UNITED STATES PATENT AND TRADEMARK OFFICE

Office Action Summary	Application No. 10/523,950	Applicant(s) PRISMALL, IAN JAMES	
	Examiner Nahid Amiri	Art Unit 3679

DETAILED ACTION

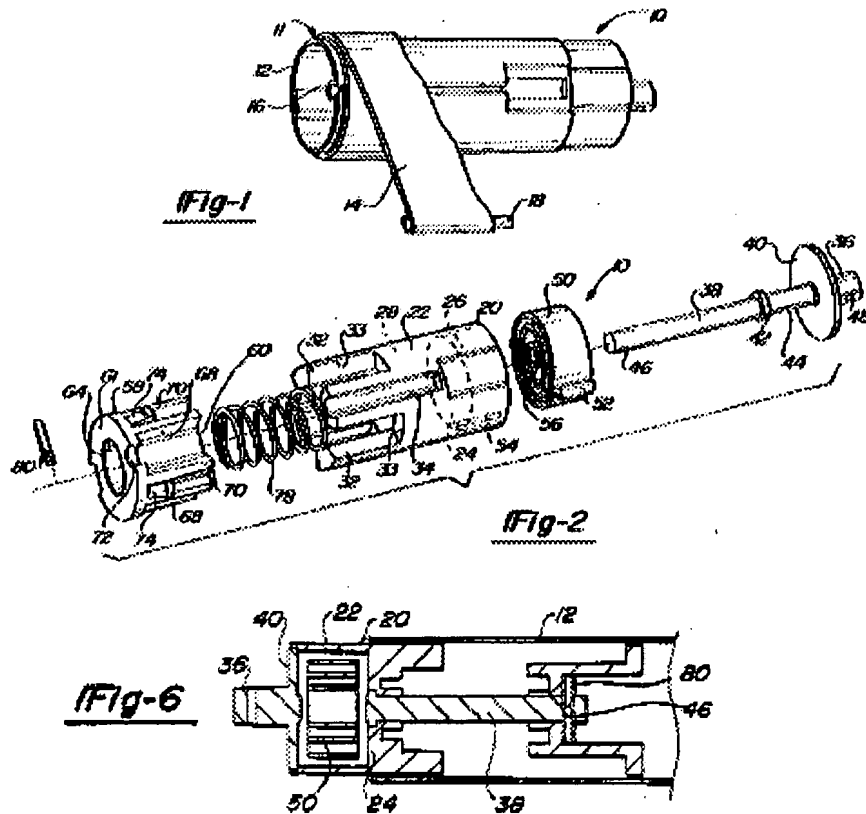
With respect to claims 1-8 and 12, Price et al. disclose a retractable barrier system (10, Figs. 1-2) comprising a support member (20), a spool (50) supported for rotation by the support member (20), a spring (78) arranged to provide a biasing load to the spool (50), and a skirt (58) the spring (78) being located beneath the skirt (58) and the skirt (58) being arranged to deflect water away from the spring (78) which would otherwise impinge on the spring (78); wherein the spring (78) is located beneath the spool (50); wherein the skirt (20) is carried by the spool (50); having all the components of the barrier system such as the spool (50) and the skirt (58) are interconnected with each other that constitutes unitary with one another; further having a cover (constituted by a wall 40 of axel 36), a closed compartment within the spring (78) is housed; wherein (Fig. 6) suggests that the cover (40) is secured to the skirt (58) by a least one snap-fit coupling; further having a fixed spindle (38) supported by the support member (20) and upon which the spool (50) is mounted for rotation; wherein the spring (78) includes a first end part anchored to the support member (20) and a second end part is capable of driving the spool (50).
